Contract #: 04-0120F4Cty: SF/ALA Rte: 80 PM: 13.2/13.9File #: 69.25B**QUALITY ASSURANCE -- NON-CONFORMANCE REPORT****Location:** Changxing Island, Shanghai, P.R. China**Report No:** NCR-000645**Prime Contractor:** American Bridge/Fluor Enterprises, a JV**Date:** 20-Jan-2010**Submitting Contractor:** Zhenhua Port Machinery Company, Ltd (ZPMC), Changxing Island**NCR #:** ZPMC-0616**Type of problem:**

Reference Description: ZPMC performed Base Metal Repair on 6AW Edge Panel (SPCM material) without prior Engineer's approval

Subject: NCR No. ZPMC-0616

Nonconformance Report

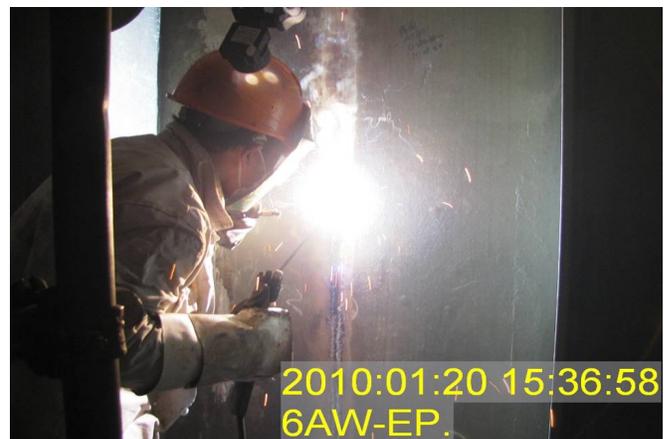
- Base metal repairs (BMR) were being performed without Engineer's approval or Critical Weld Report (CWR) at a location where a T-Rib stiffener had been removed.
- These BMR's were located along the 6AW Edge Panel at panel point (PP) 40.75 Cross Beam side.
- Y location measured from PP 41 is: 1 meter
- The removed T-Rib stiffener is identified as: X106M(FS)
- The Edge Plate located at 6AW is identified as: EP30B
- The material is identified as: A709M Grade 345 Seismic Performance Critical Member (SPCM).
- The approved drawing sheet reference is: EP30

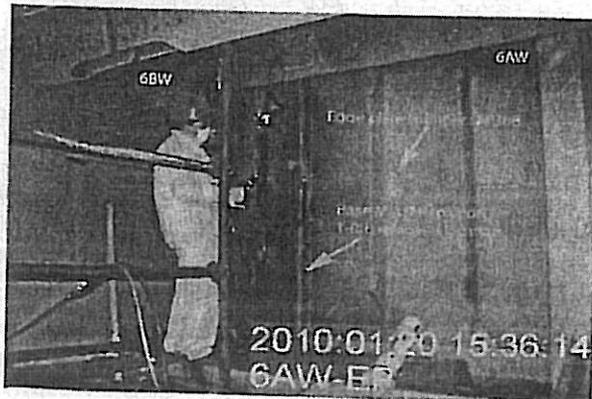
- Base metal repairs (BMR) were being performed without Engineer's approval or Critical Weld Report (CWR) at a location where a T-Rib stiffener had been removed.
- These BMR's were located along the 6AW Edge Panel at panel point (PP) 40.75 Cross Beam side.
- Y location measured from PP 41 is: 1 meter
- The removed T-Rib stiffener is identified as: X106M(FS)
- The Edge Plate located at 6AW is identified as: EP30B
- The material is identified as: A709M Grade 345 Seismic Performance Critical Member (SPCM).
- The approved drawing sheet reference is: EP30
